Project No.: 0171-120-01-08
File: CAM-4, 3.6

RE: Reference NIRB Screening No. 01DN003 for the Clean Up of CAM-4, Pelly Bay DEW Line Site

UMA Engineering Ltd. is submitting the proposed amendments to the October 2000 submission to the Nunavut Impact Review Board (NIRB) for the clean up of the CAM-4, Pelly Bay DEW Line Site. The proposed amendments are being submitted on behalf of Defence Construction Canada and the Department of National Defence.

DEPARTMENT OF NATIONAL DEFENCE			
DEW LINE CLEANUP			
TITLE:	CAM-4 (PELTY BAY) - SITE PLAN		
JOB No.	0171-120-13-01	DATE:	JANUARY 2003
SCALE:	1 : 10000	DWG. No.	FIG 01
CHECKED:	KMS

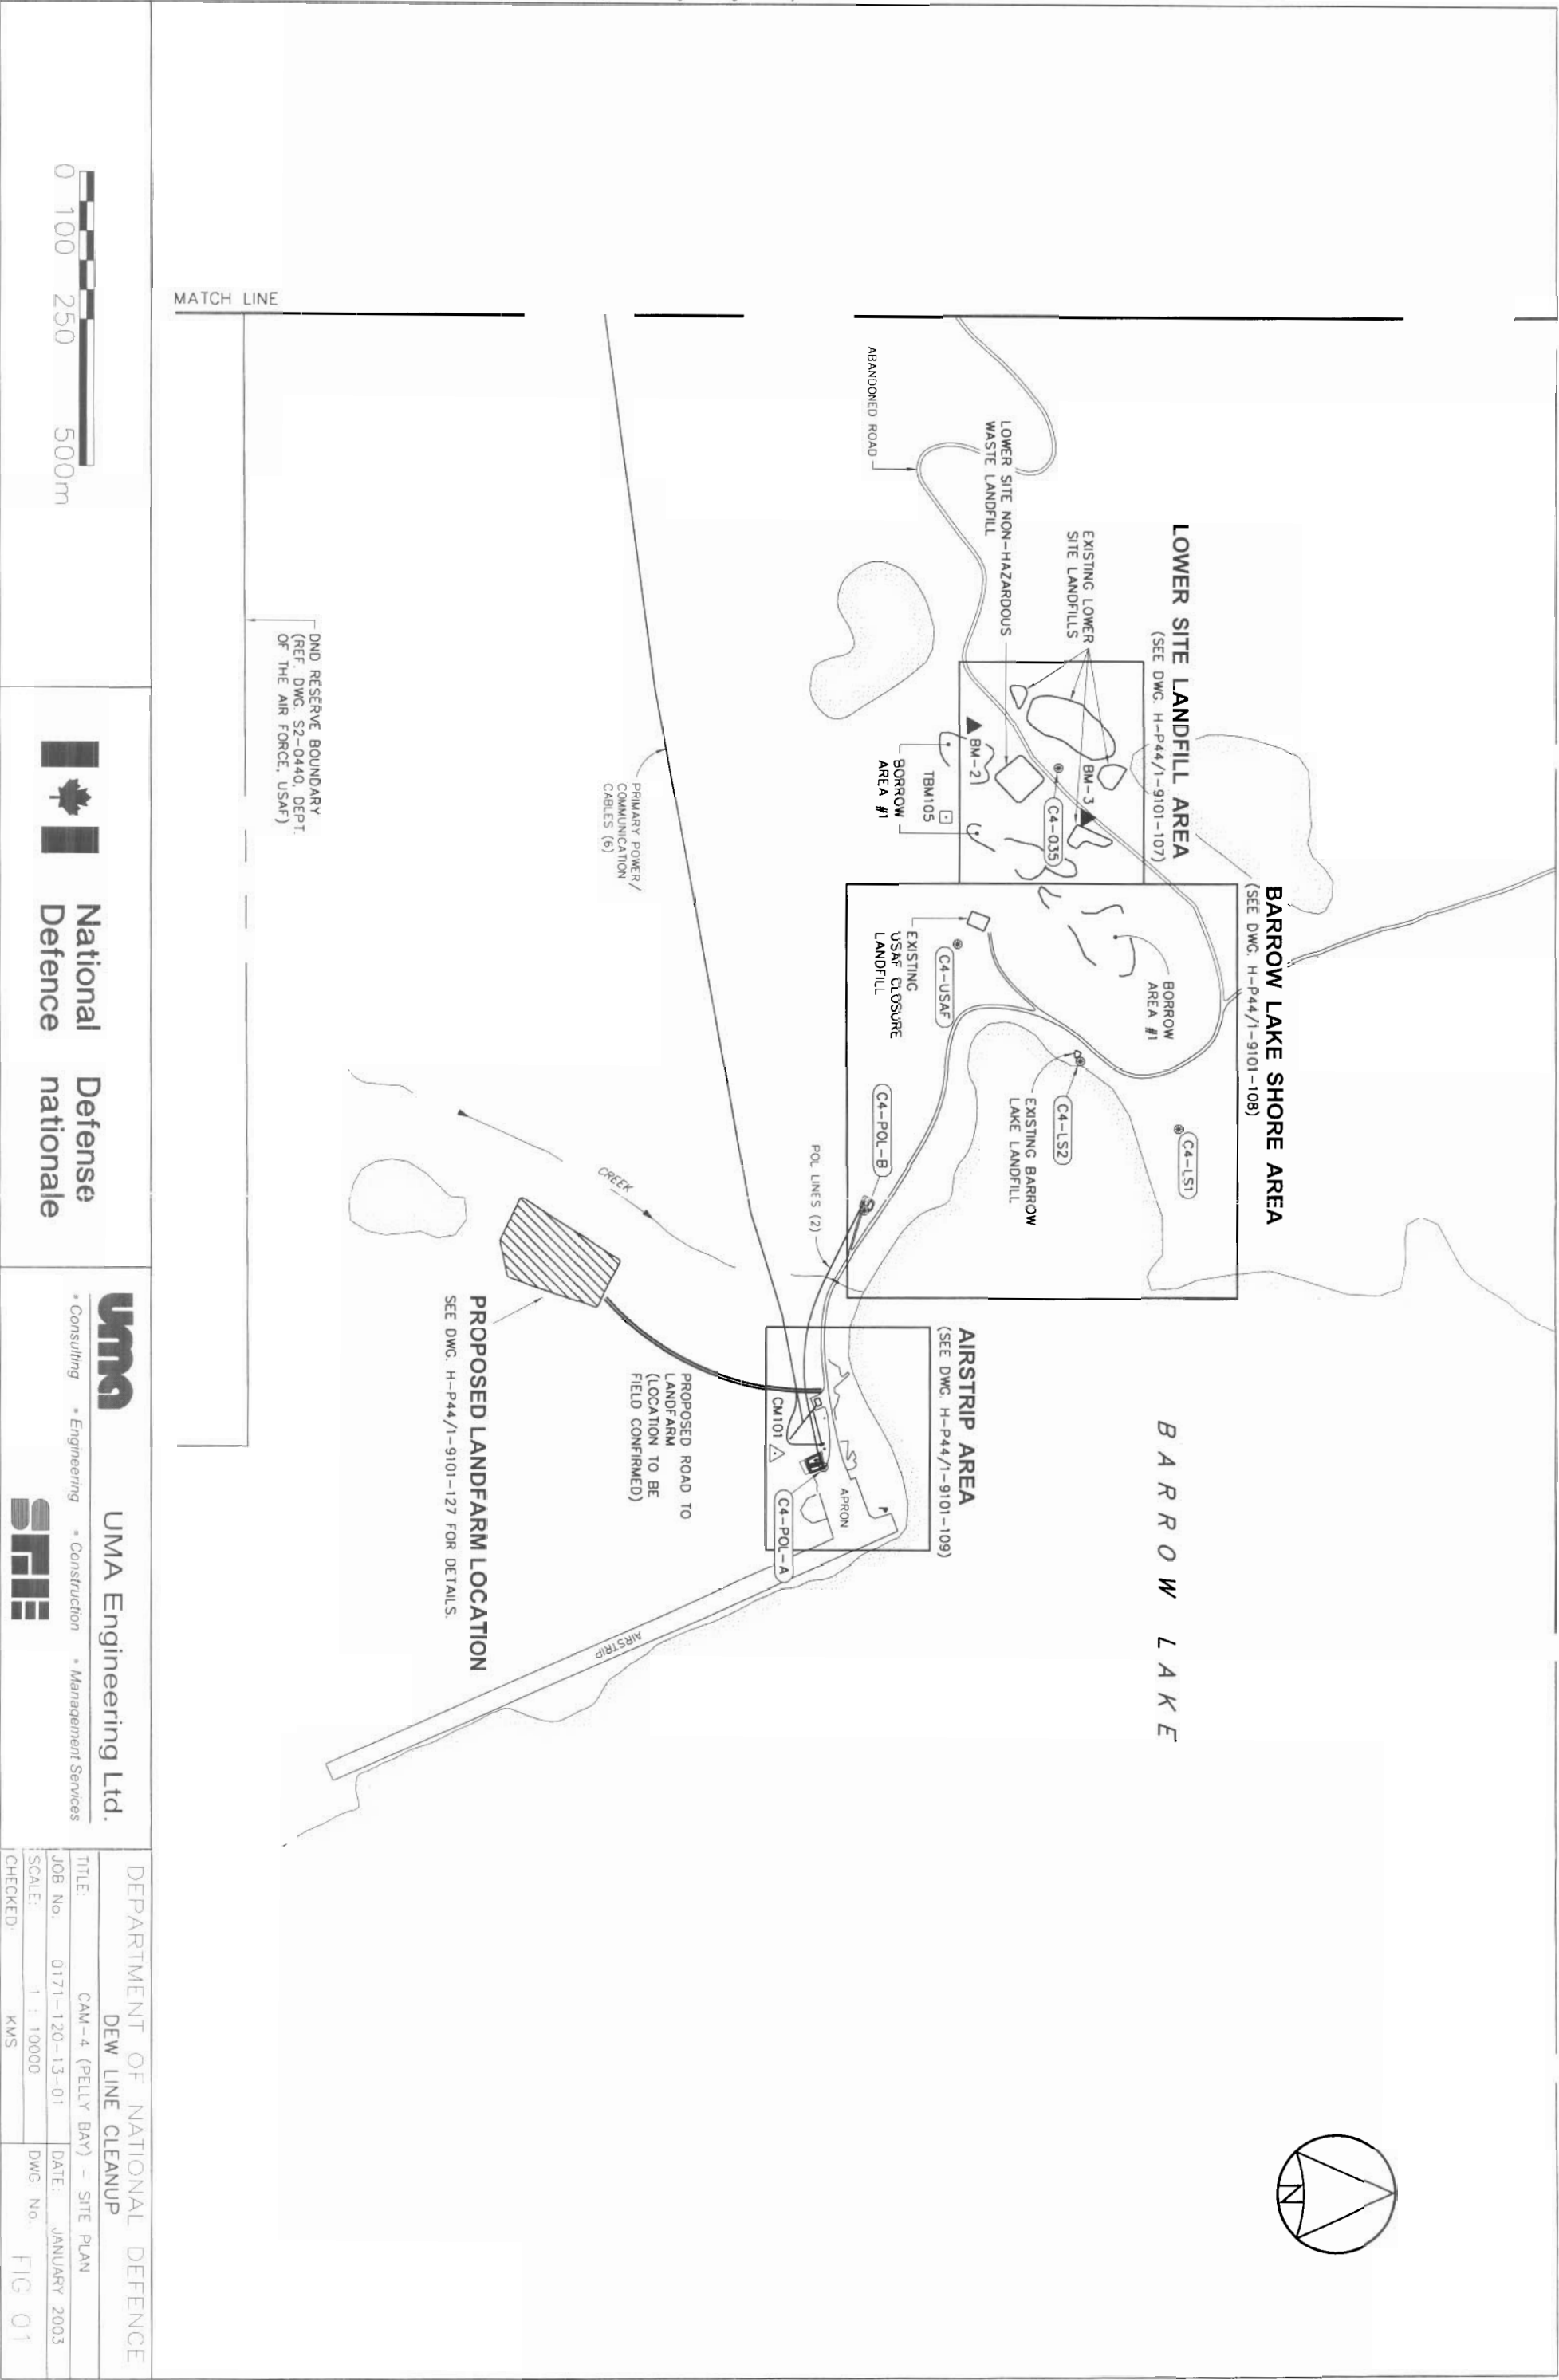
The second amendment to the October 2000 NIRB submission is the relocation of the landfarm. The original location shown in the 2000 submission was discarded because of wet ground conditions and intermittent surface water drainage through the location. The new area proposed for the landfarm is located approximately 400 metres southwest of the Hangar Area (Figure 01). The proposed footprint of the landfarm remains as 1.7 hectares.

TITLE:	CAM-4 - PROPOSED LANDFARM CROSS SECTION
JOB No.	0171-120-13-01
SCALE:	1 : 300
CHECKED:	KMS
DATE:	JANUARY 2003
DWG. No	FIG 04

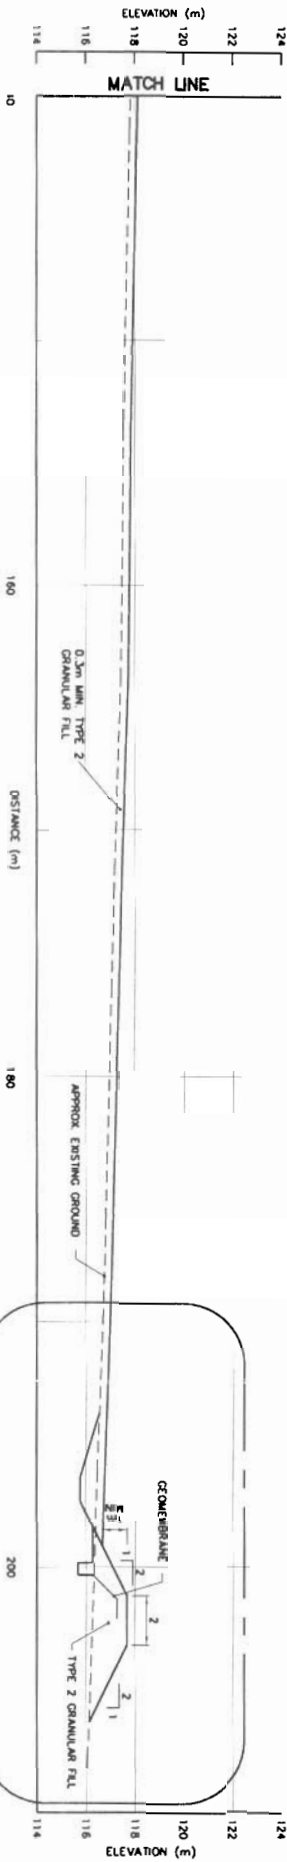
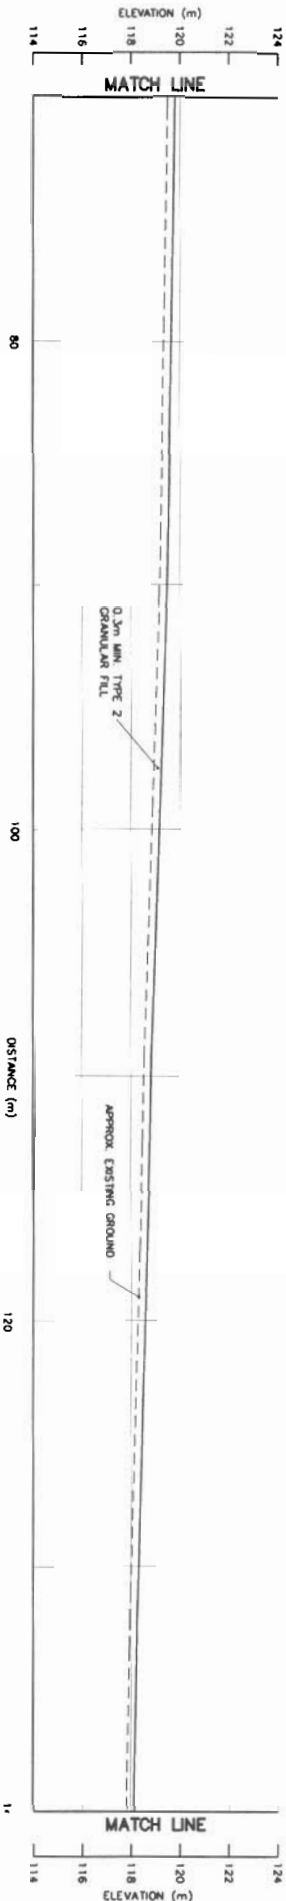
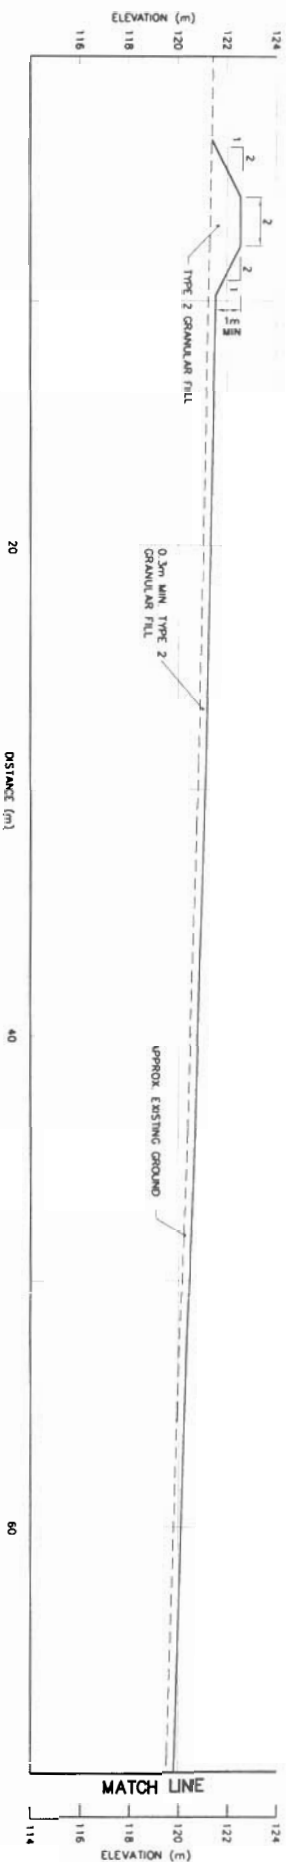
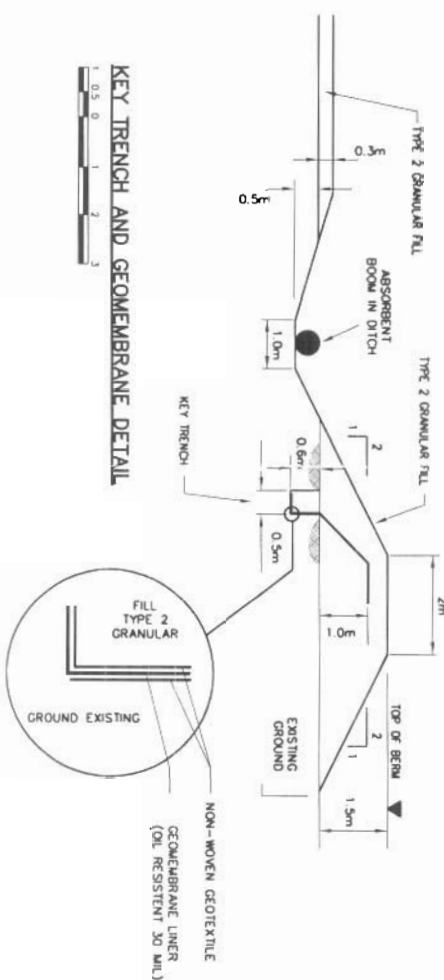
A 0.3 metre thick leveling course of gravel will be placed across the base of the treatment area prior to construction of the perimeter berms, as shown on Figure 03. The berm height will be 1.0 and 1.5 metres in the southwest and northwest (downgradient) portions of the landfarm, respectively (Figure 04). Due to the shortage of suitable fine-grained soils for berm construction in the area, and because of the proximity of the creek and potential aquatic receptors to the proposed landfarm area, a geomembrane liner will be incorporated into the down-gradient berms. The liner will be keyed into underlying low-permeability soils, and any surface water runoff from within the treatment area will be directed towards a sump at the northwest corner of the treatment area. The northwest end of the landfarm has been designed to have sufficient storage capacity to contain spring freshet or precipitation events that may occur during the operation of the landfarm. Water may be used for moisture conditioning of the soil throughout the treatment season. All excess water and water collection in the perimeter collection system will be tested prior to discharge in accordance with the environmental protection measures detailed in the original application. Upon closure, the treated soil within the landfarm will be consolidated in a portion of the landfarm and covered with clean fill, and the area graded to prevent ponding.
